**CITY OF MERCED PROJECT NO. CP220061
CHANGE ORDER NO. 2**

PROJECT NAME: Community Park 42

Additional work to add underground electrical, water. Quantity adjustment for additional asphalt per the contract unit price.

REF. SPECIFICATION:
Bid Item #23 - 6" Sewer
DRAWING: C2.1, C2.2, C2.3, C2.4,
C2.5,C2.6

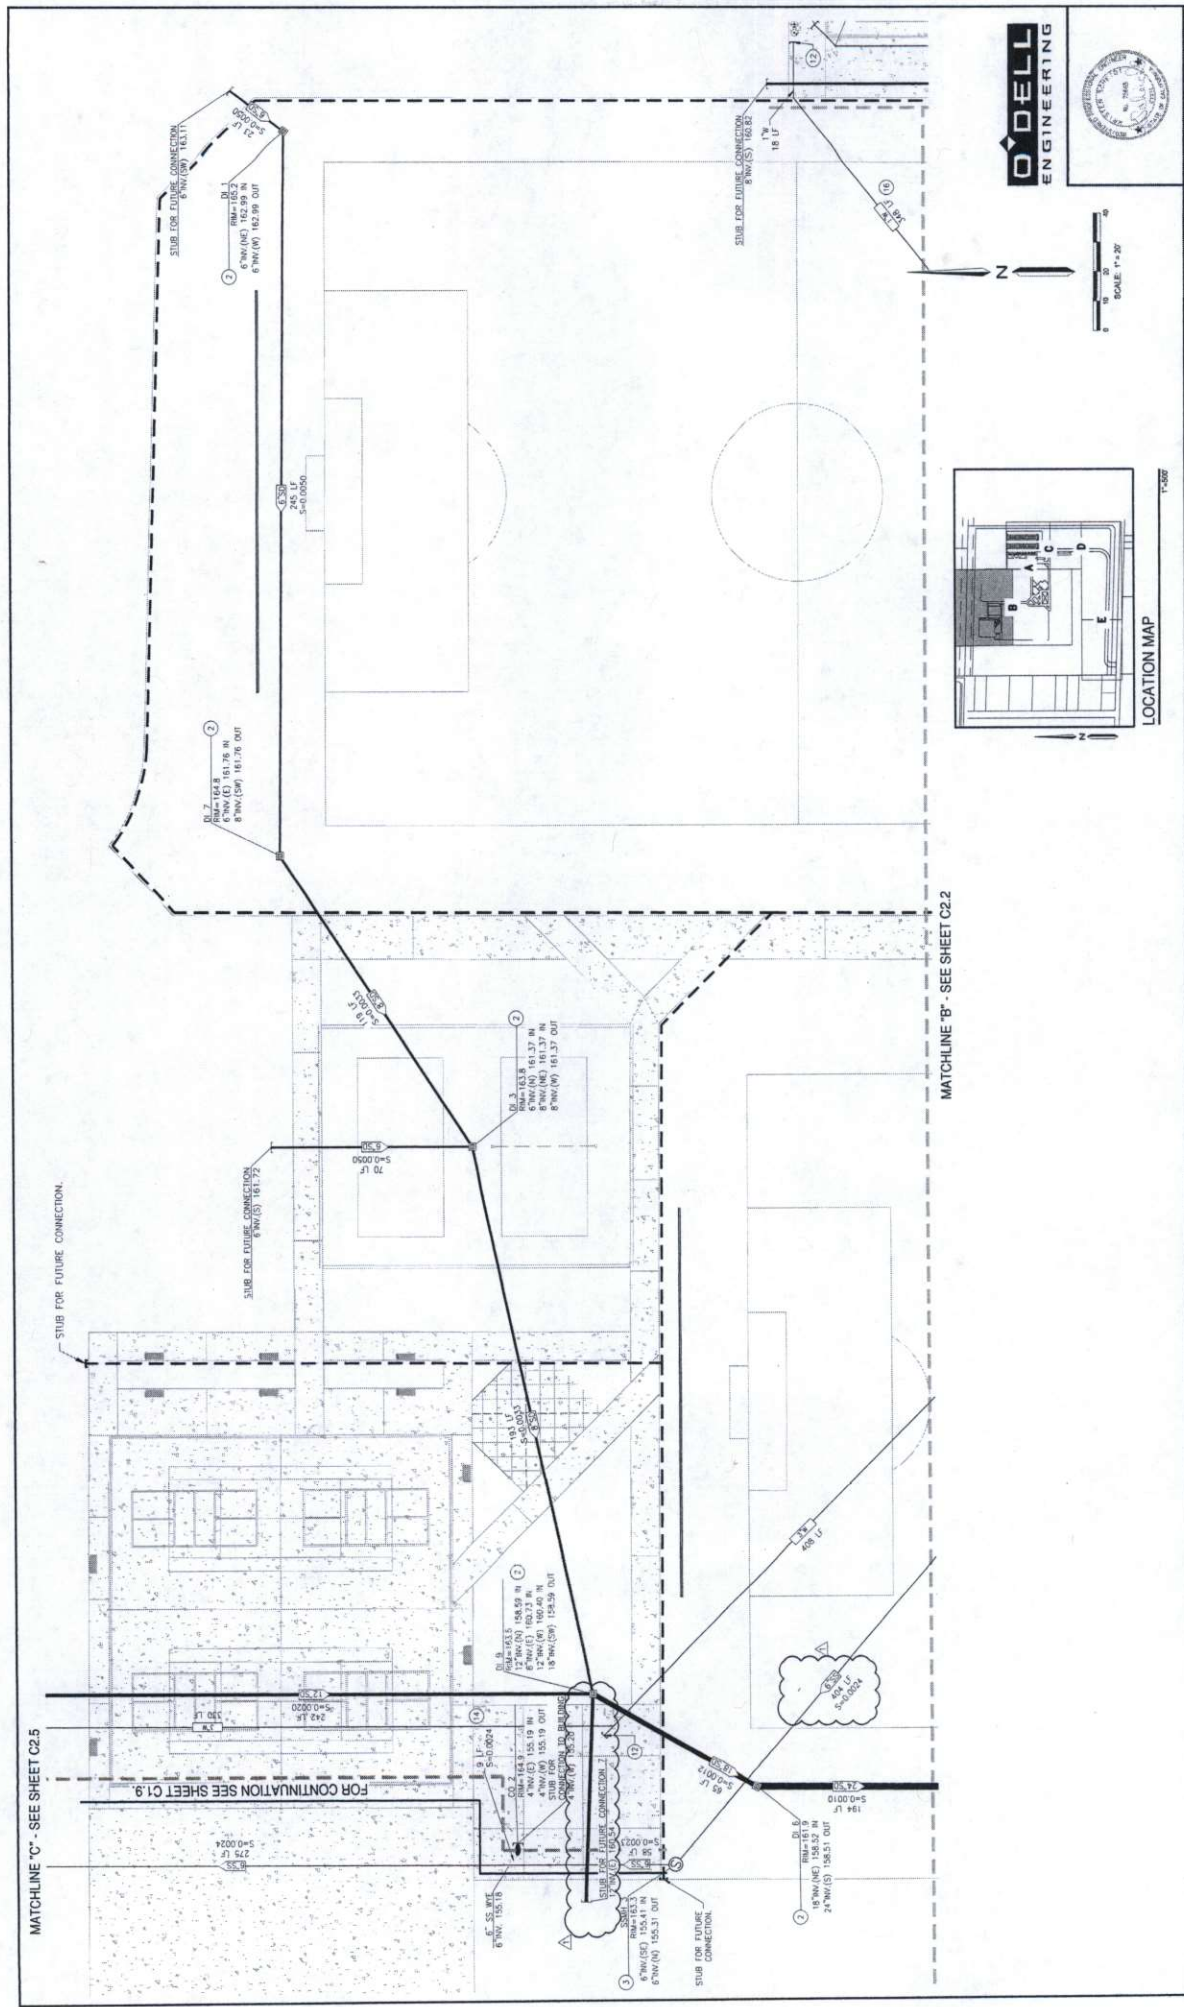
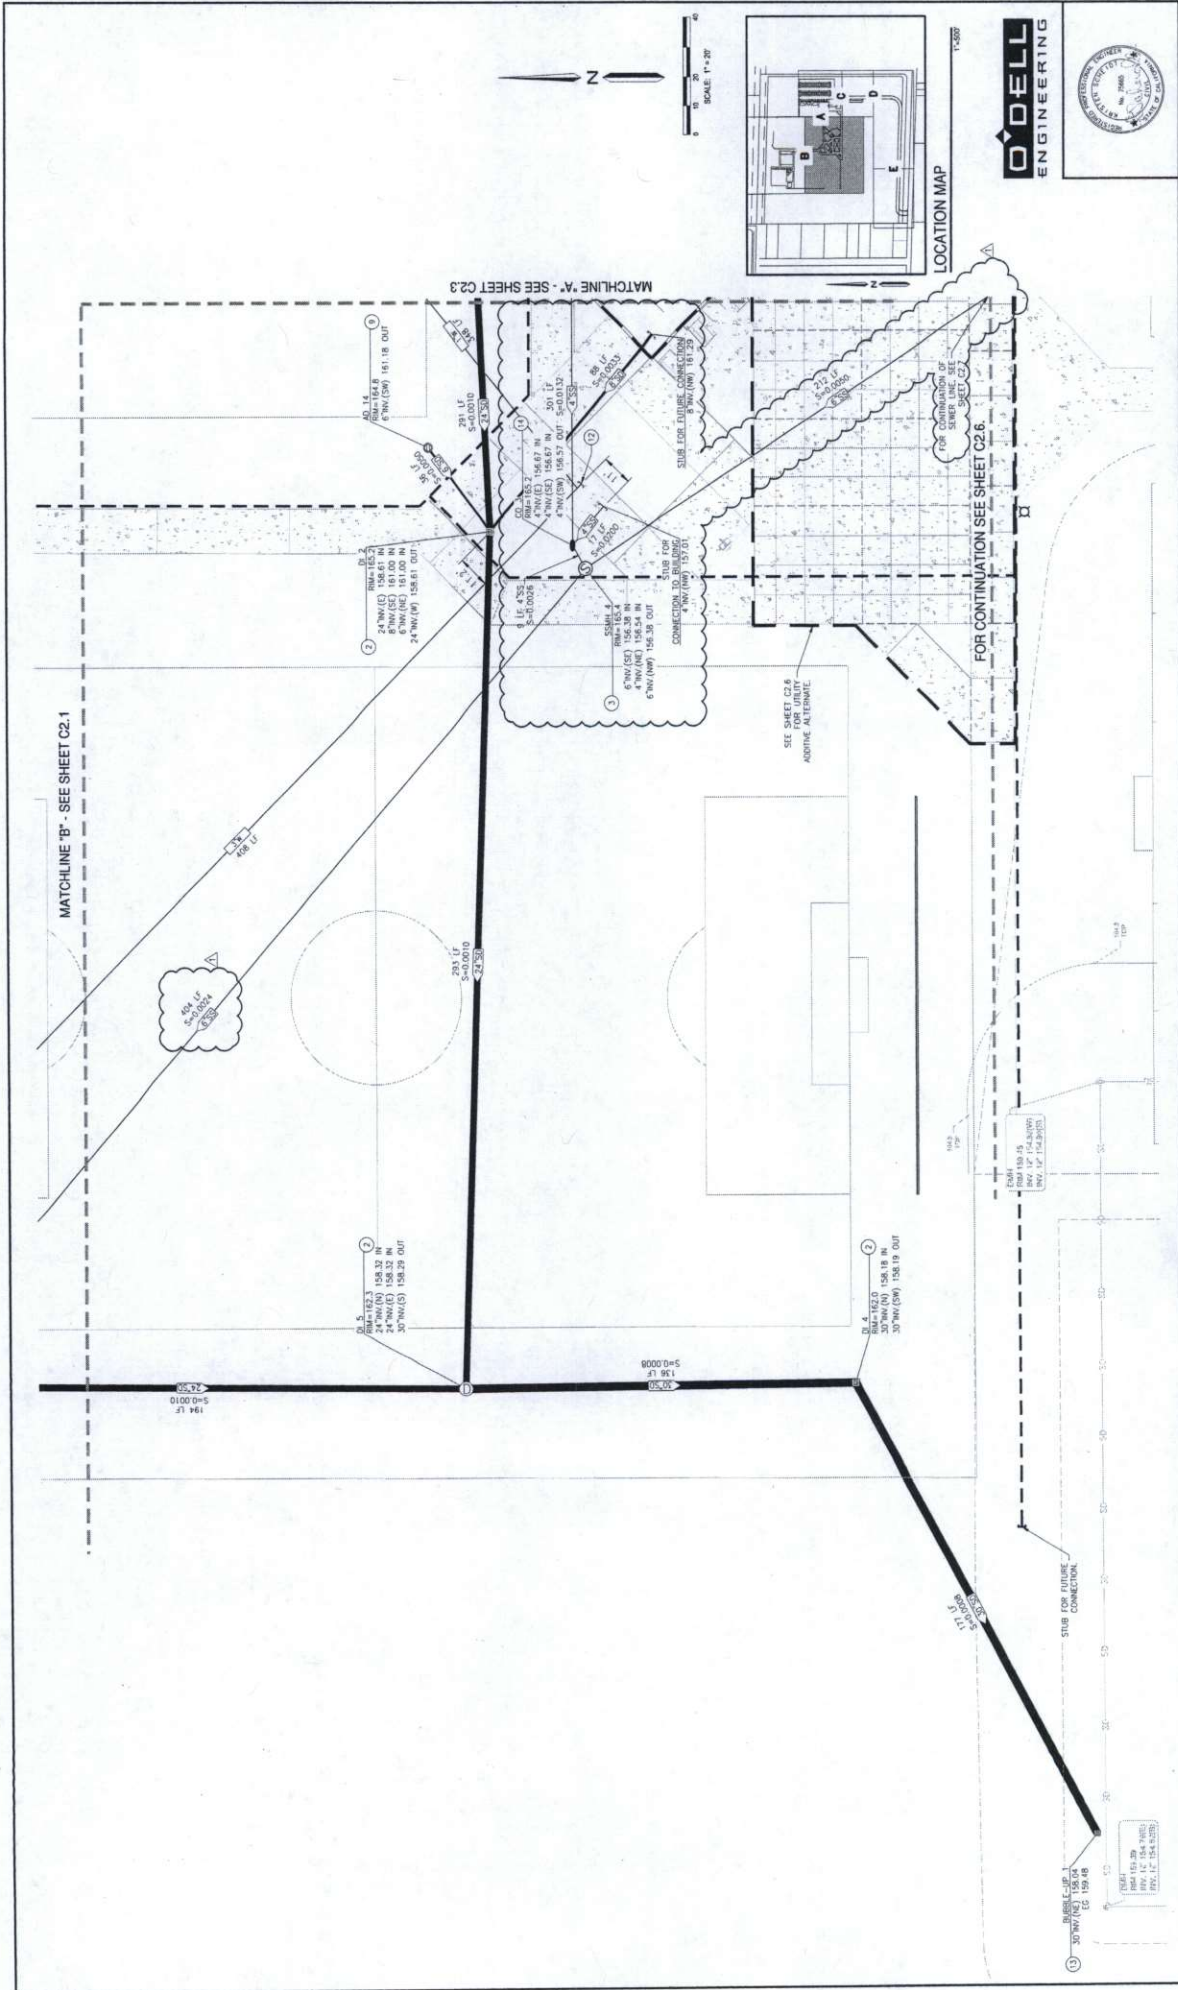
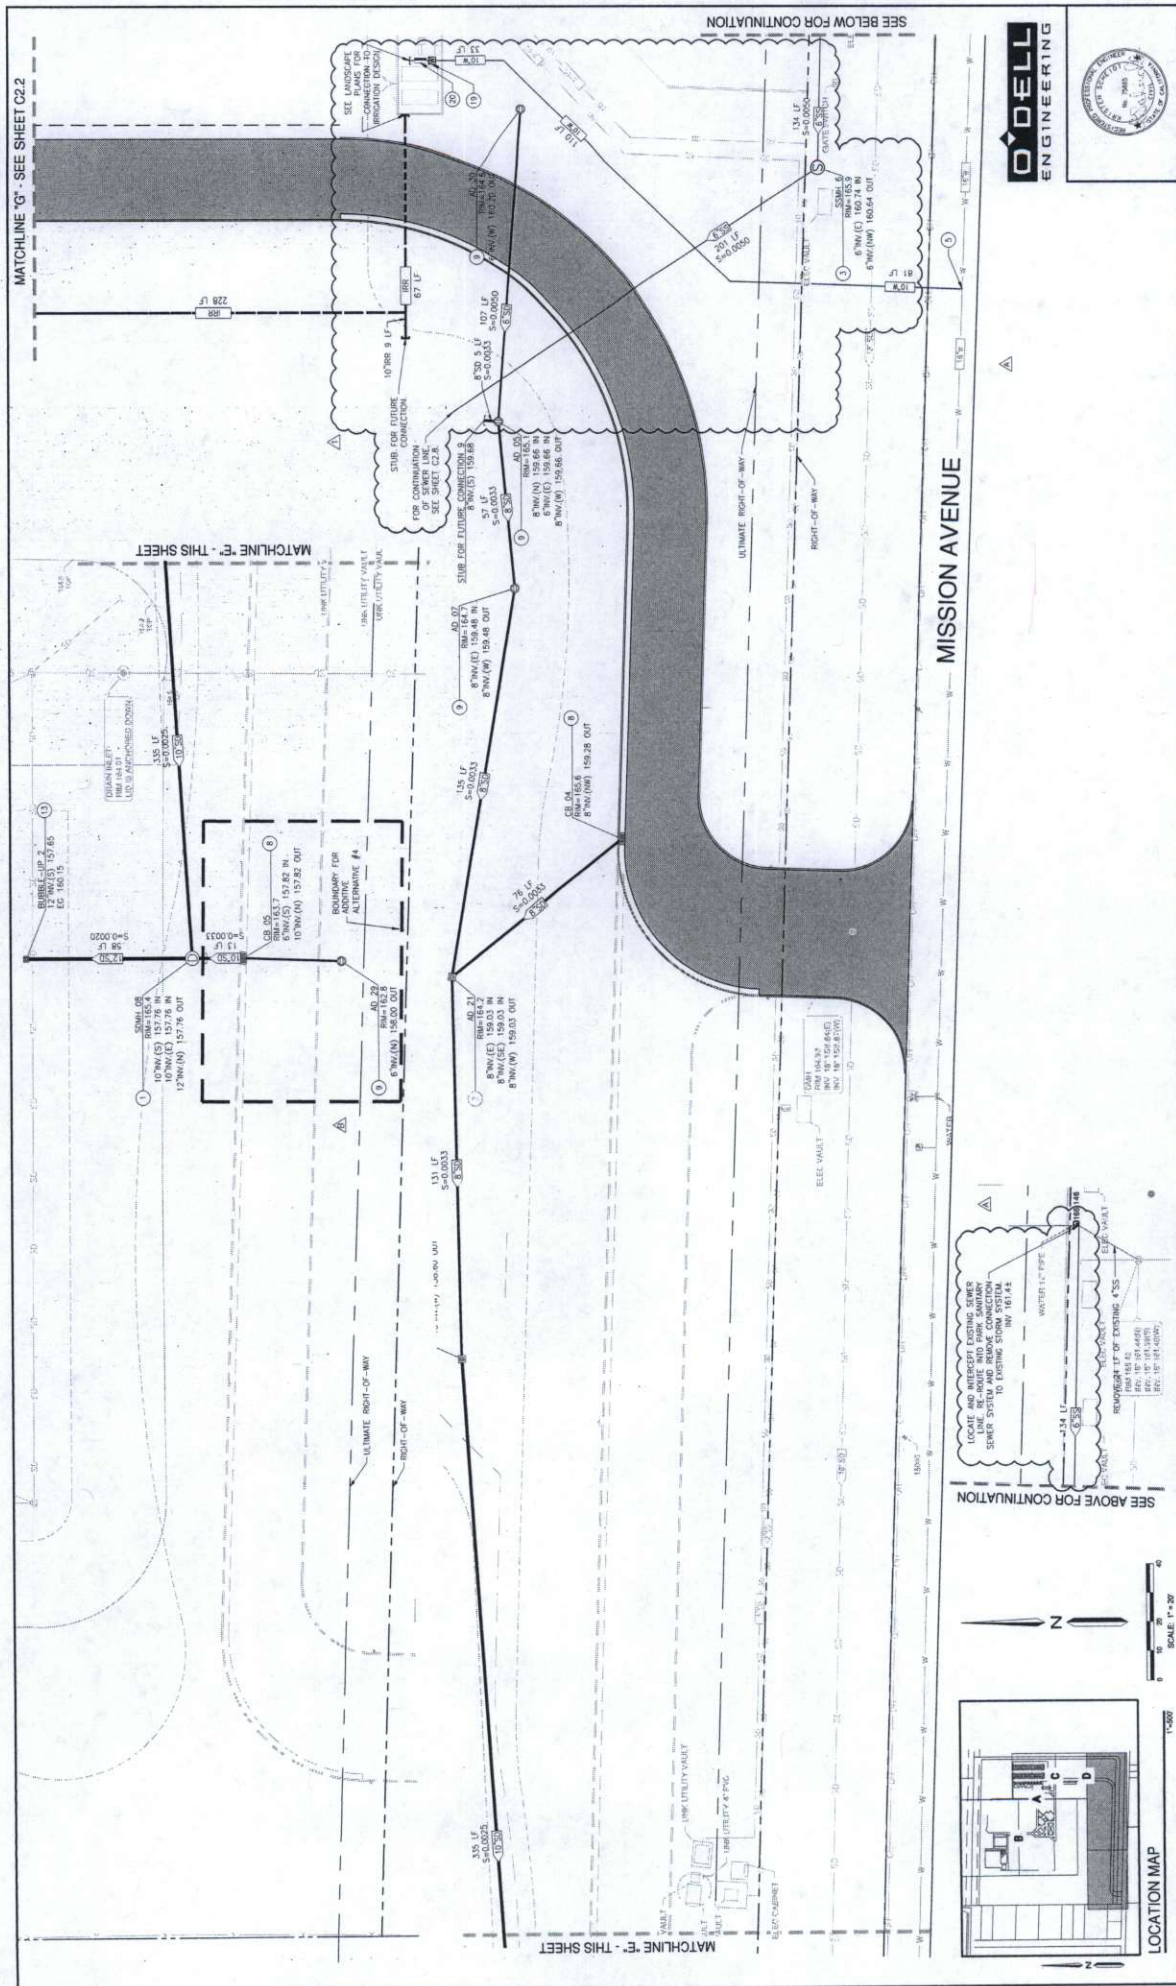
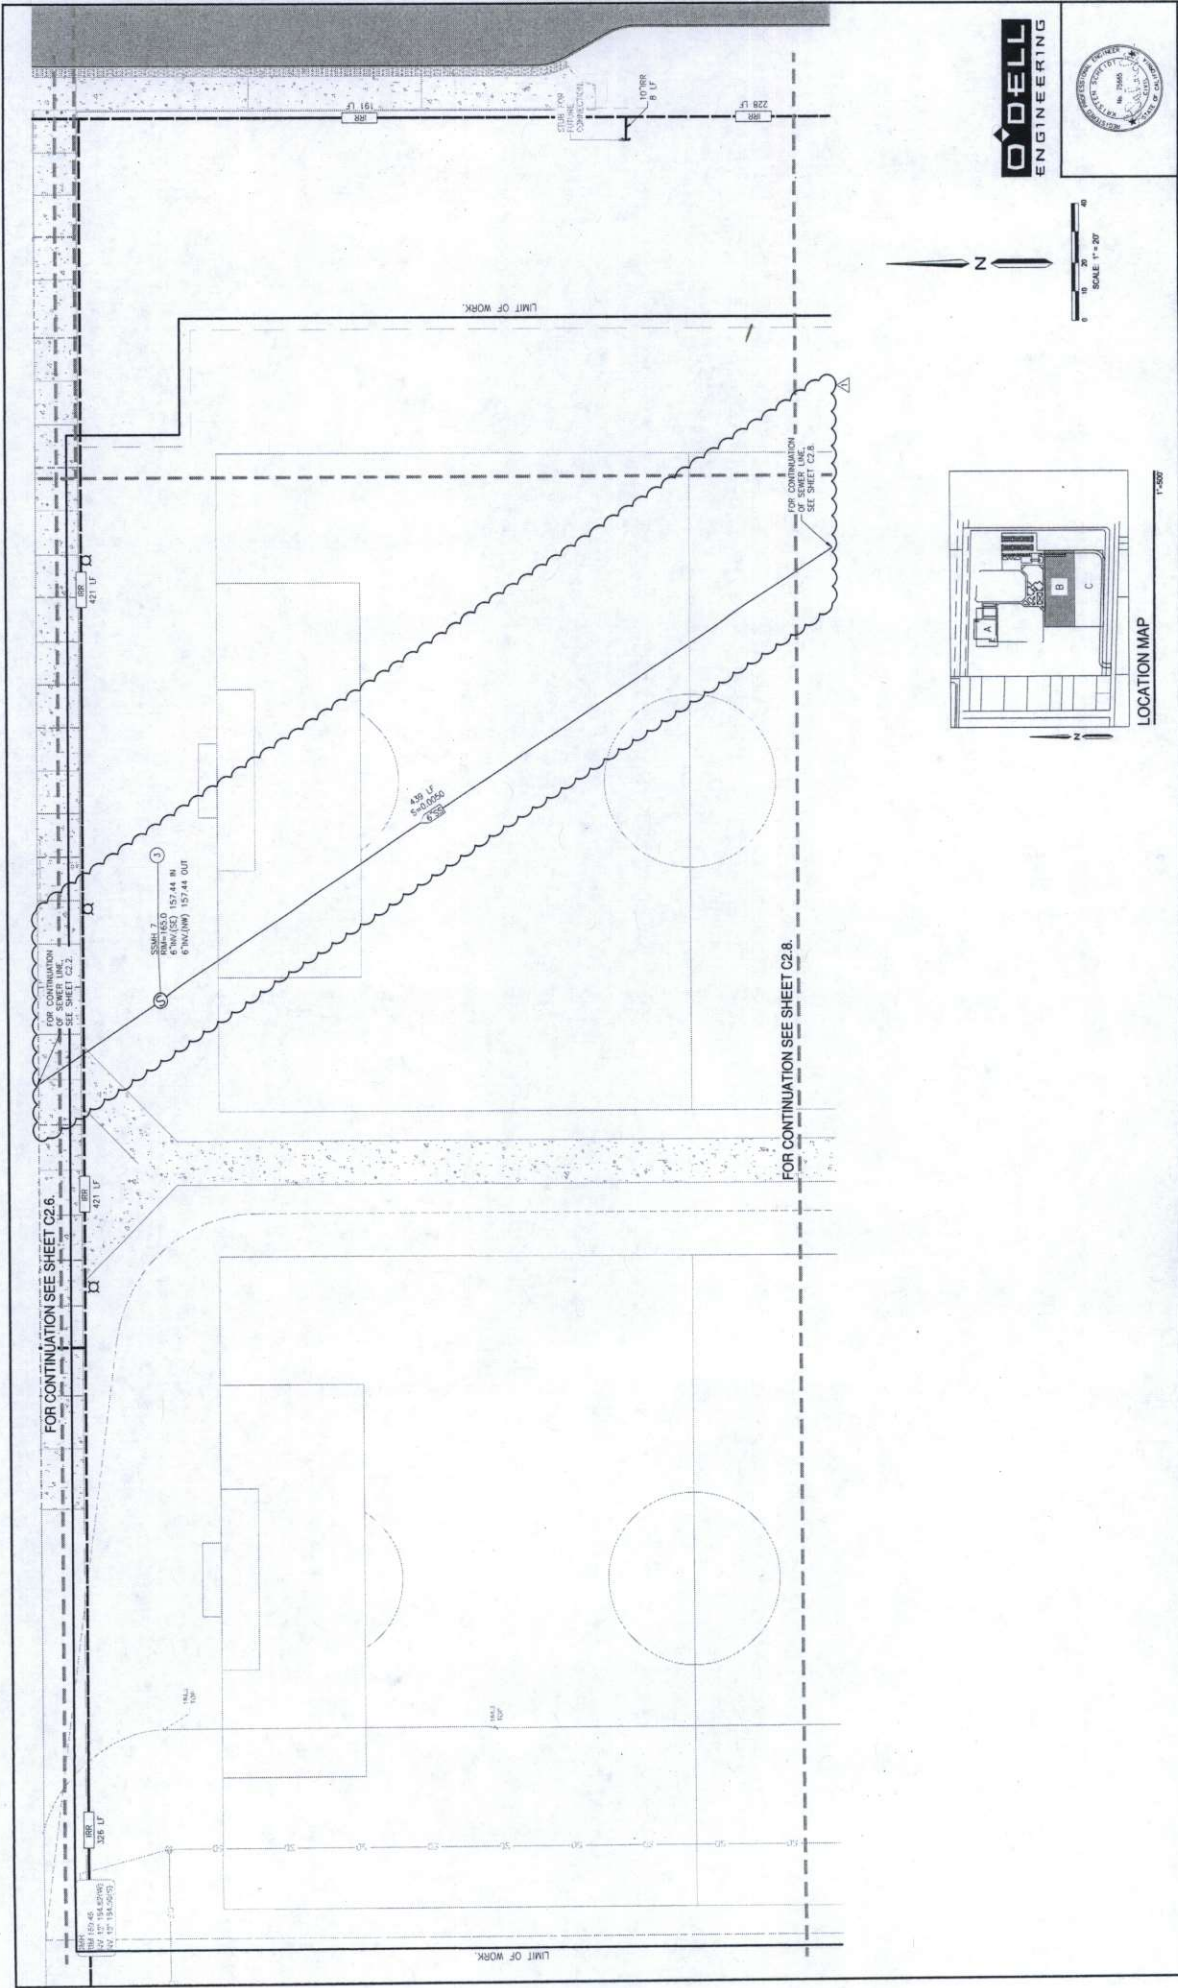
REQUEST: Bid Item # 23 - 6" Sewer shows a quantity of 1,170 LF. When we preformed our take off,
we found 2,830LF shown on the plans. That's an additional 1,660LF. Please verify quantities.

REPLY: See sheets C2.1 to C2.5 and C2.7 to C2.8 Rev 1 dated 8/16/23 showing revised
sewer line routing between concession building and well site 20. Line item 23 on
Bid Schedule A to be updated to 2,561 LF.
